12 NORTH FEW STREET  
Project No. 13840, Contract No. 9084

Work associated with Developer Agreement

SHEET TITLE:  
**SITE PLAN**

SHEET NUMBER:  
**C1.0**

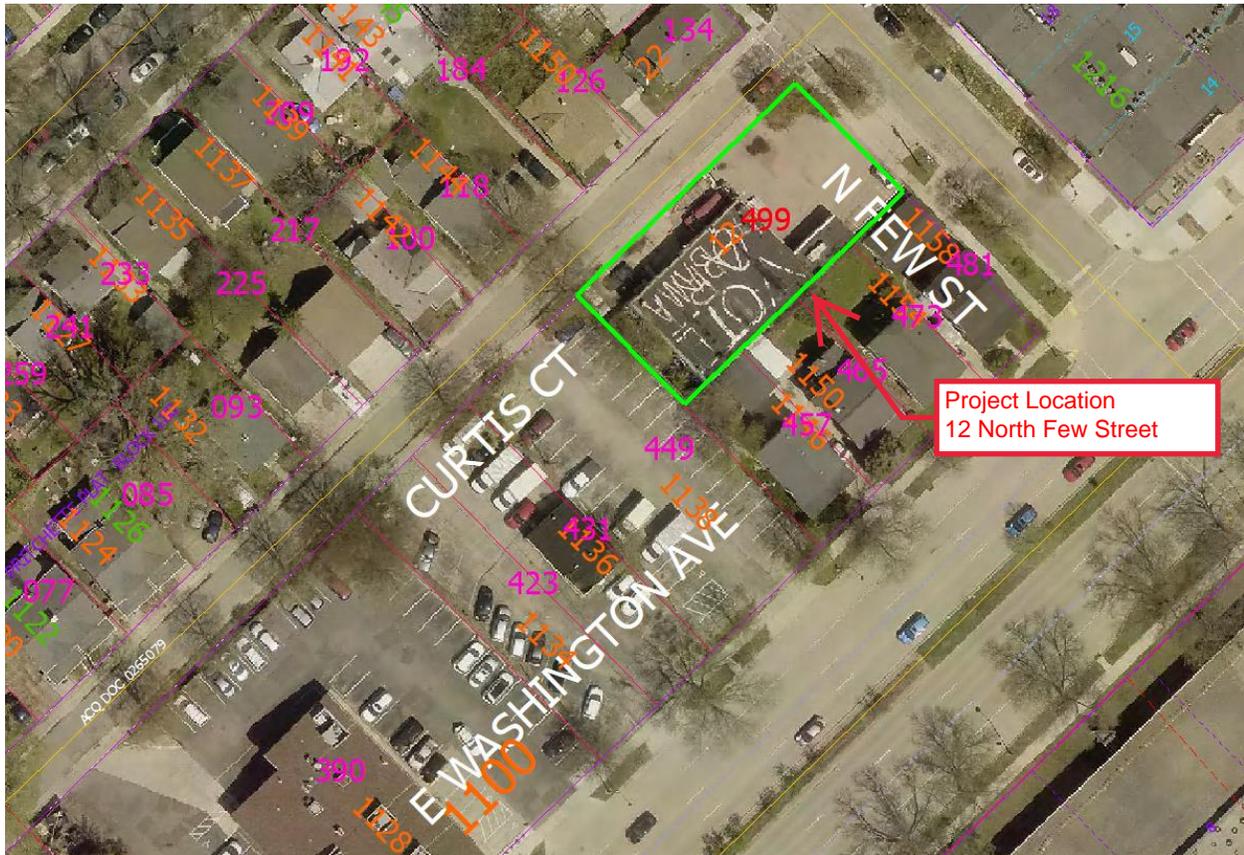
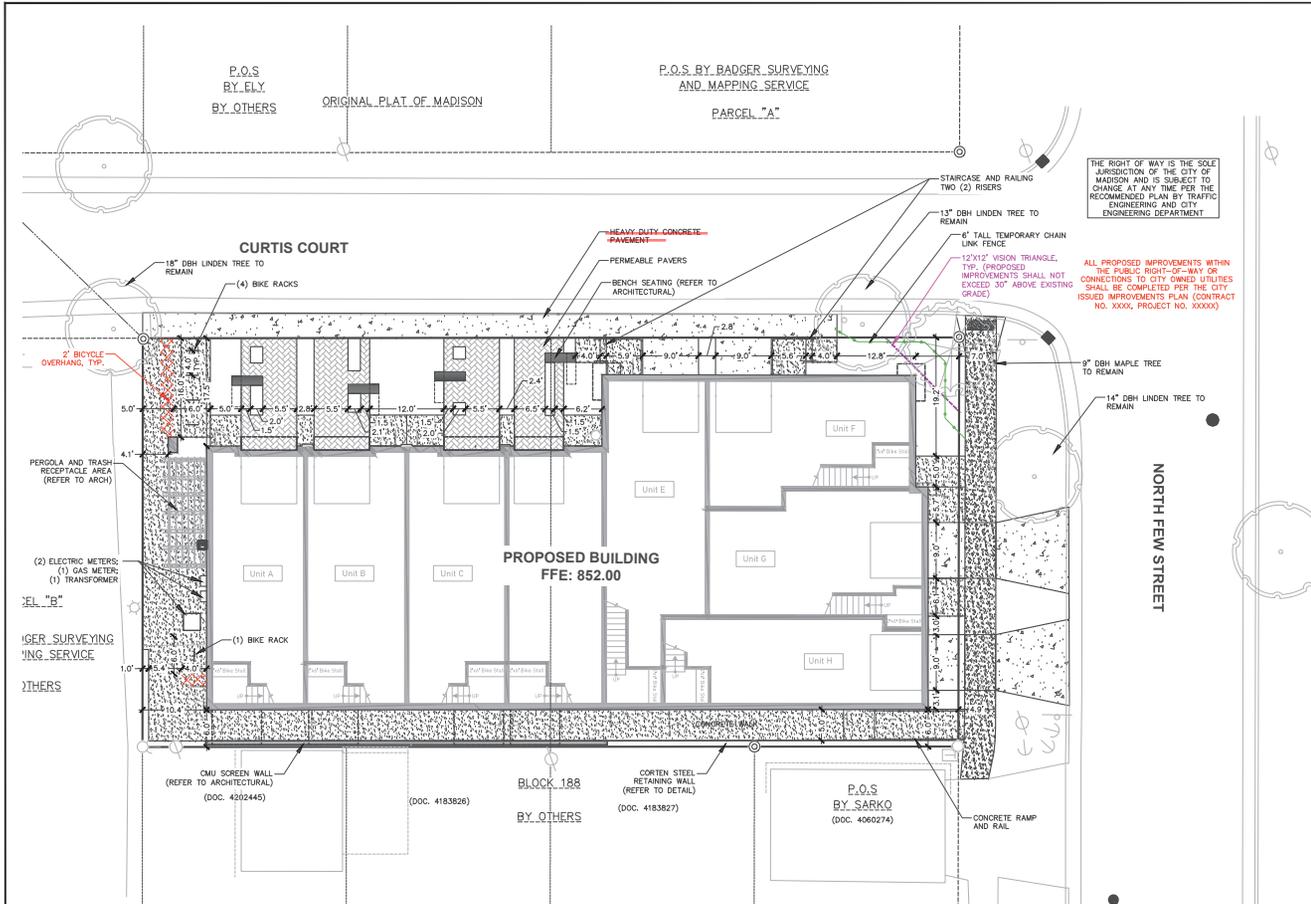
- Private sanitary, water and storm lateral connections into public system.
- Sidewalk ~~on Curtis Court and~~ North Few Street.
- Tree protection for trees on Curtis Court and North Few Street.
- Tree installation on North Few Street as required by City Forestry.
- Installation of streetlights on existing MGE poles along Curtis Court as required by Traffic Engineering.

**Sidewalk installation on Curtis Court and North Few Street adjacent to project.**

**Tree in right-of-way on Curtis Court near North Few Street to remain.**

**Tree on North Few Street to remain.**

SHEET NUMBER:  
**C3.0**

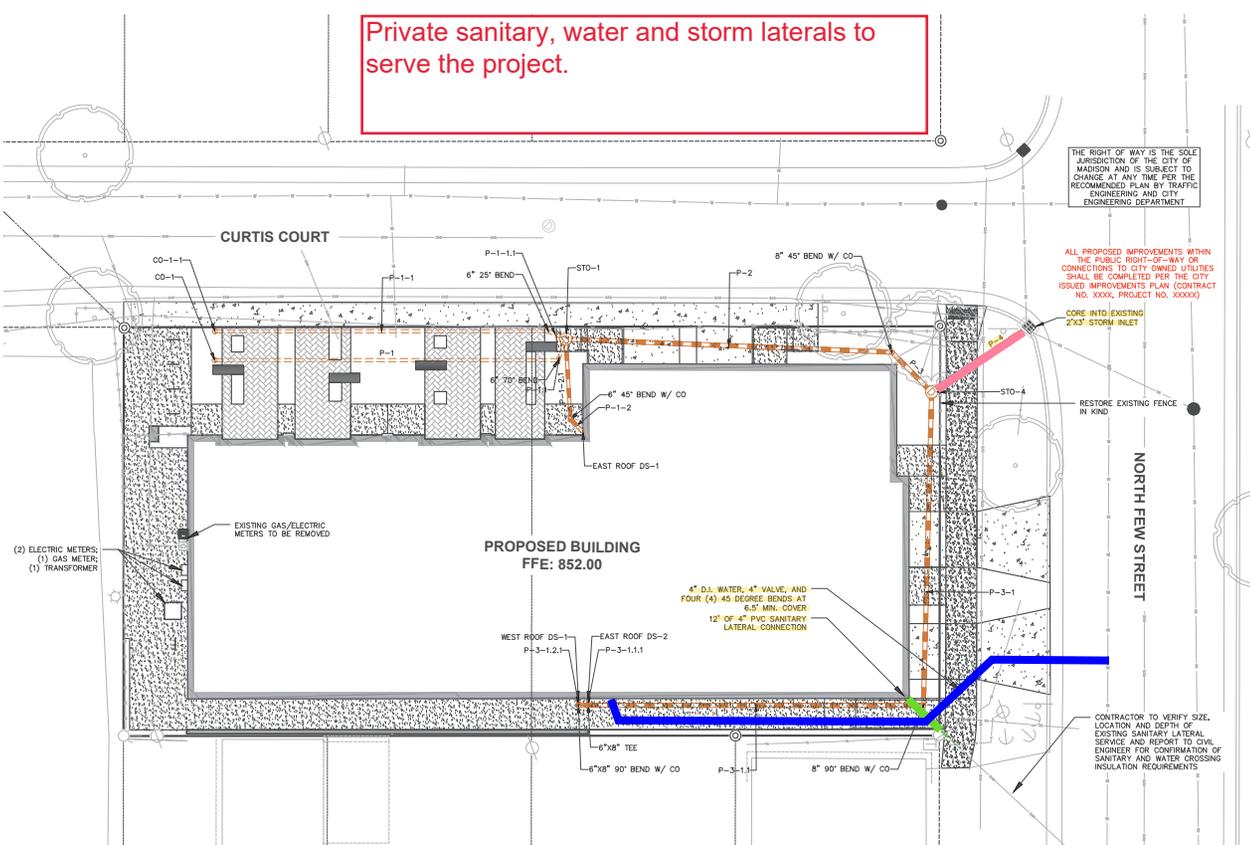
Private sanitary, water and storm laterals to serve the project.

SHEET NUMBER:  
**L1.0**

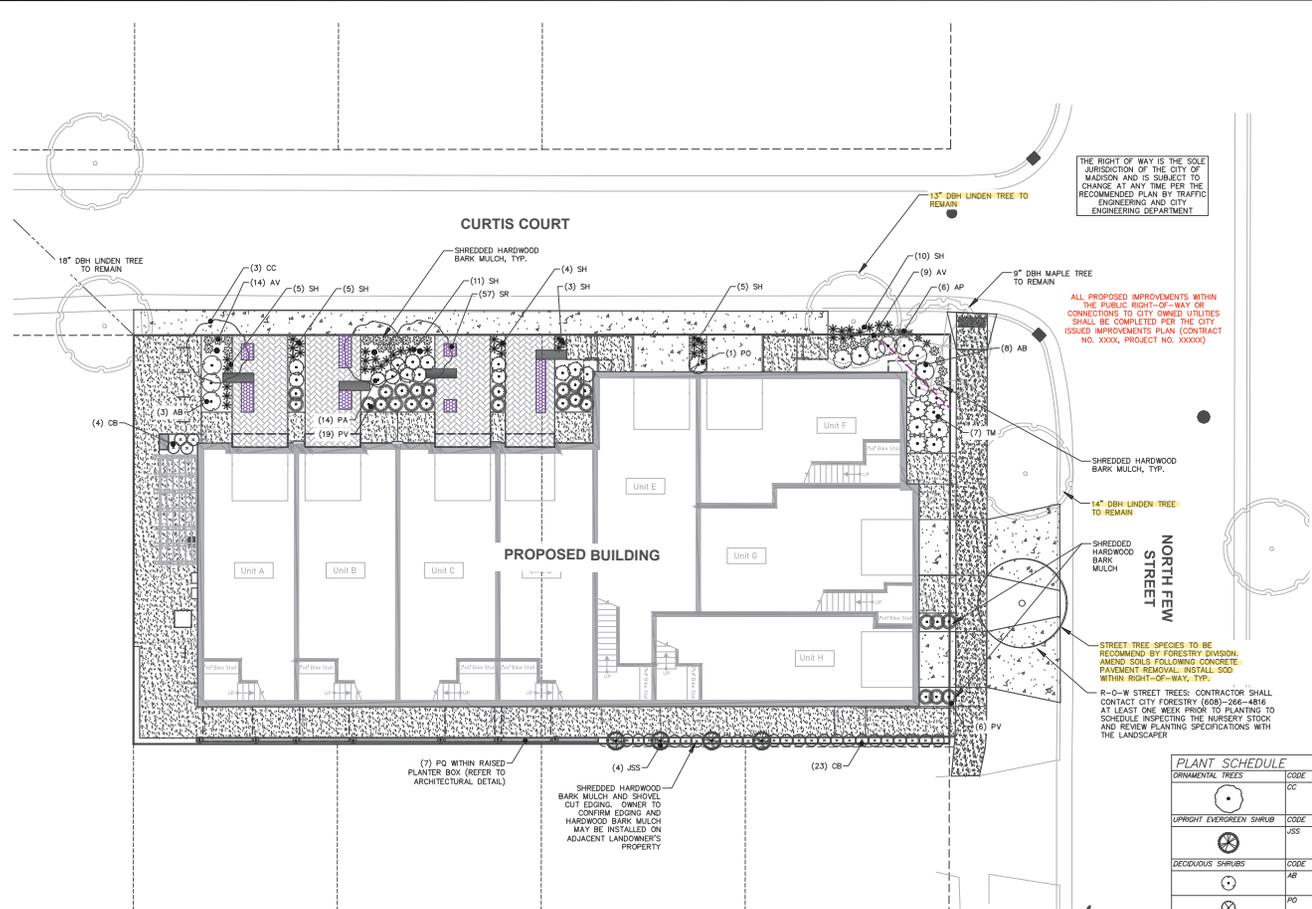
Existing tree on Curtis Court and North Few Street to remain.

If possible, new tree between concrete aprons on North Few Street per City Forestry
